# CAPITOL

July 27, 2018

Heather Stouder  
Planning Unit  
City of Madison

Re: 122 State St. Hotel Proposal

**Figure: Hotel Skyline Rendering provided to the Steering Committee**

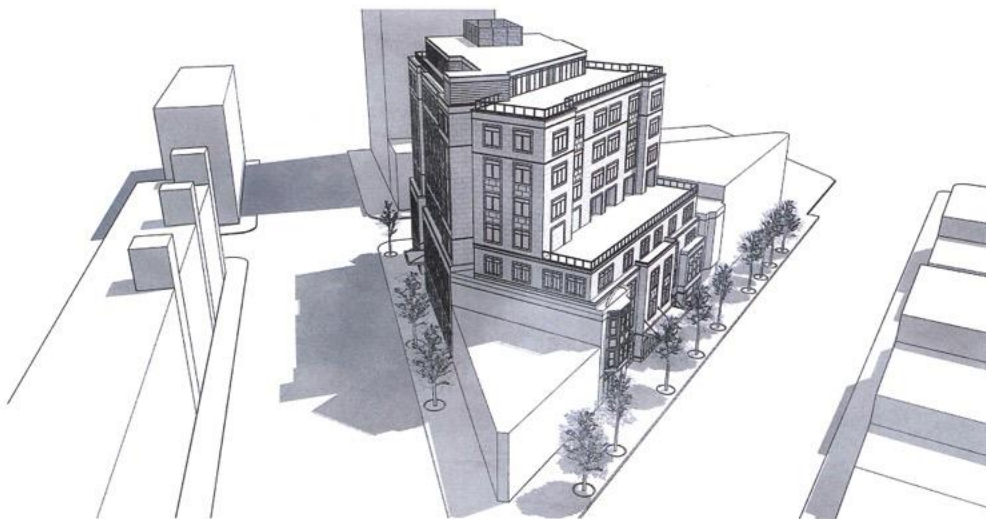
\* **Architectural Enhancements:** The current design for the "122 State Street Project", shared with the Steering Committee at our June 14 meeting, is well-thought-out and attractive. In fact, its visual and vertical articulations actually complement the existing downtown skyline adjacent to the Dayton – Carroll Street intersection, as well as the established building height along its State Street aspect. (See Figure.)

Because this building, as proposed, so well complements the existing downtown skyline, we have NO PROBLEMS/CONCERNS regarding its height. This proposed hotel is positioned to be a shining beacon of culture and urbane energy on Upper State, so let it be higher than usual; it’s exactly the type of development that Madison should be emphasizing.

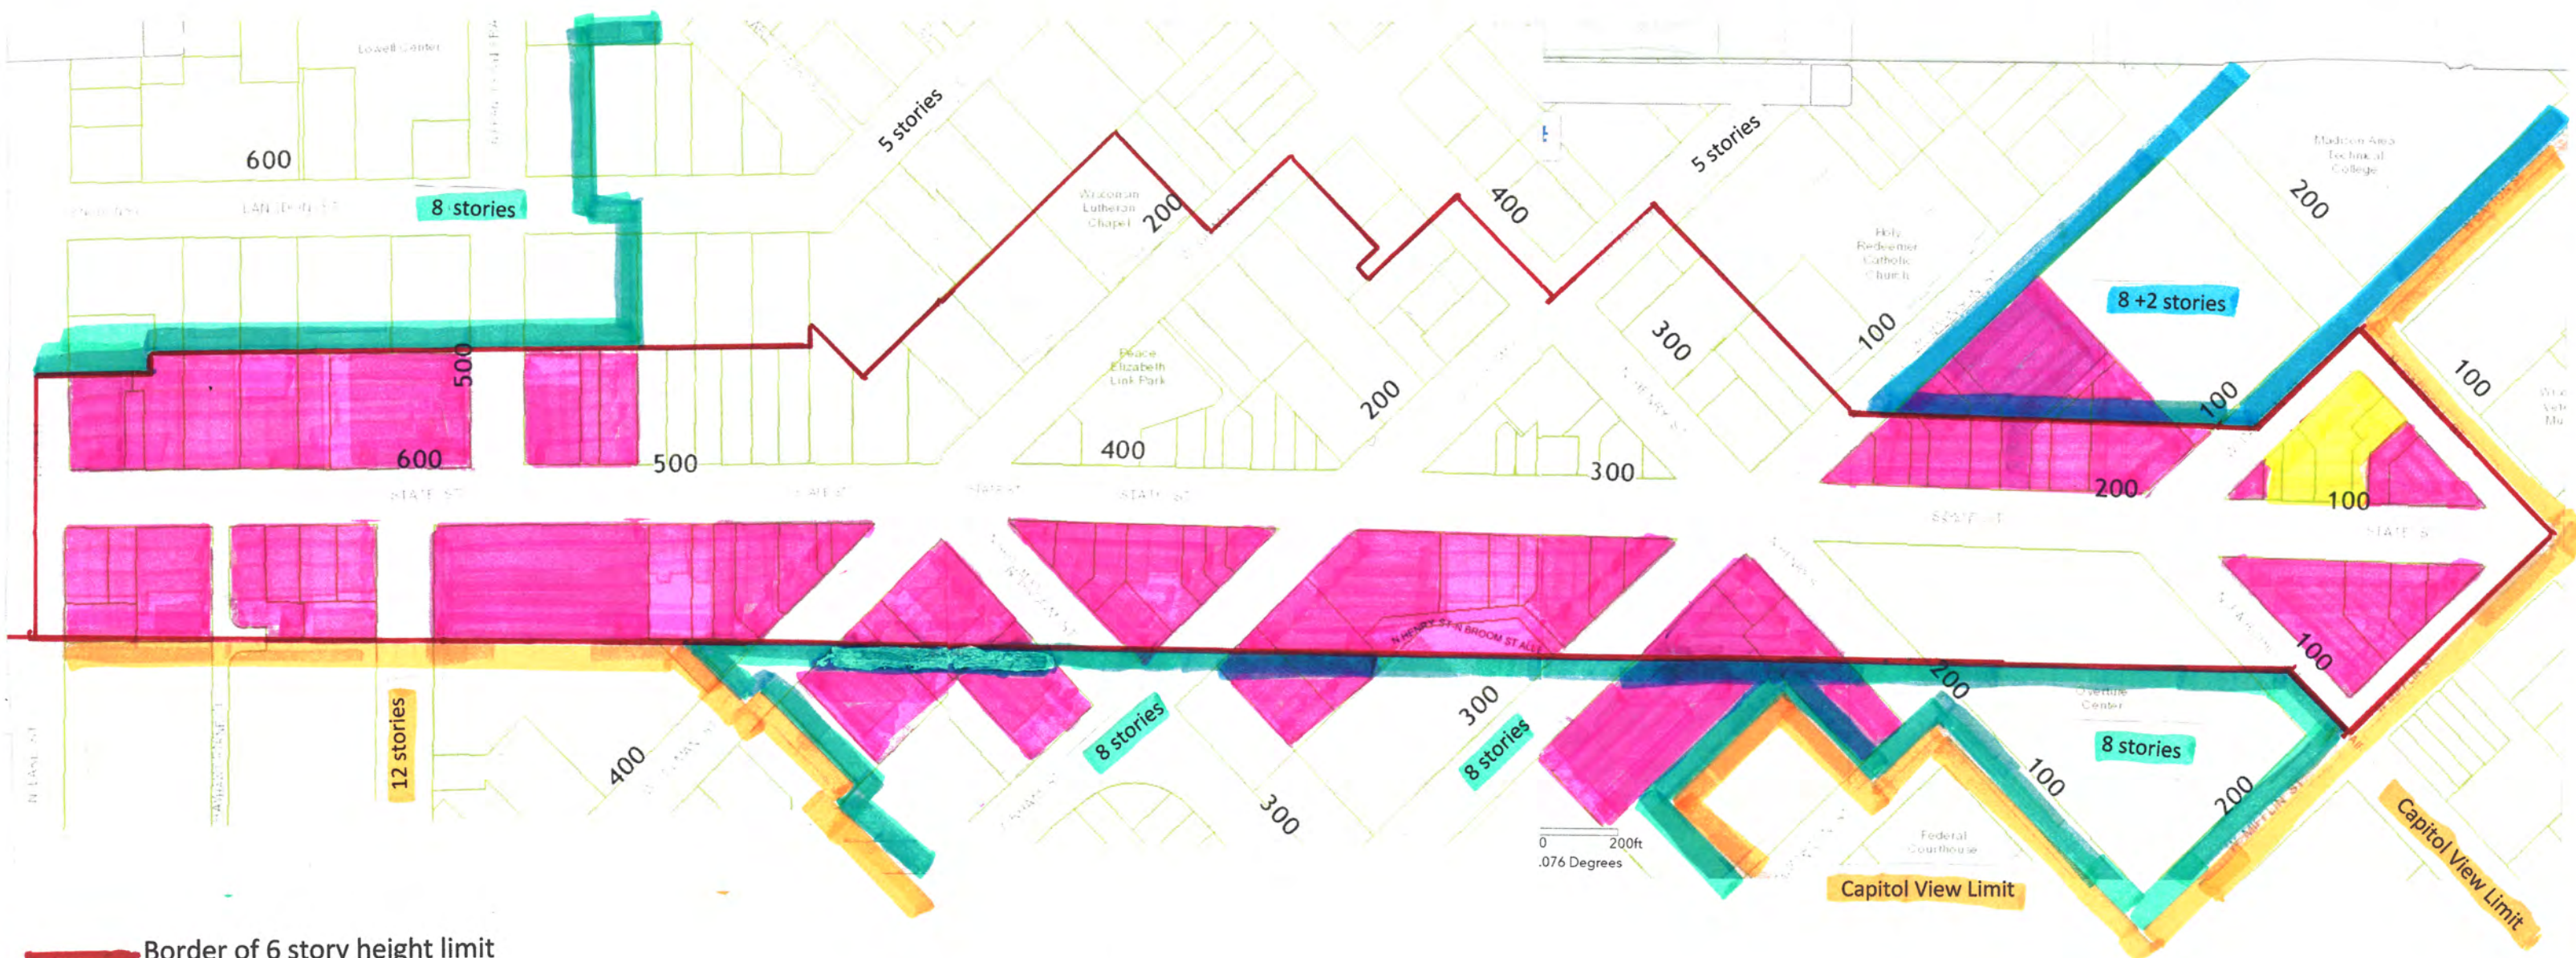
The State Street East-Facing Perspective and the Dayton St. Perspective both show what appear to be windows at the 3<sup>rd</sup> and 4<sup>th</sup> floors of the narrow elevation which overlooks the two story building at the State / Dayton corner. Plan sheets for these floors, A-2.2 & A-2.3, do not show windows in these locations. The elevation plan sheets do not identify the cladding materials at this location.

On these same perspective drawings the cladding for the 5<sup>th</sup> - 8<sup>th</sup> floors may appear to be windows in a shadow but apparently are metal panels in a pattern to match the glass. The elevation plan sheet for State St., one of several different elevations labeled A-9.0, has tags for both metal panels and glass pointing to this type of cladding.

Likewise on the Carroll Street Perspective what might appear to be windows are apparently metal panels. The floor plans show a pair of recessed decks along this side of the building at floors 2 – 8 (A-2.2 to A-2.5) which are not shown on the perspective.
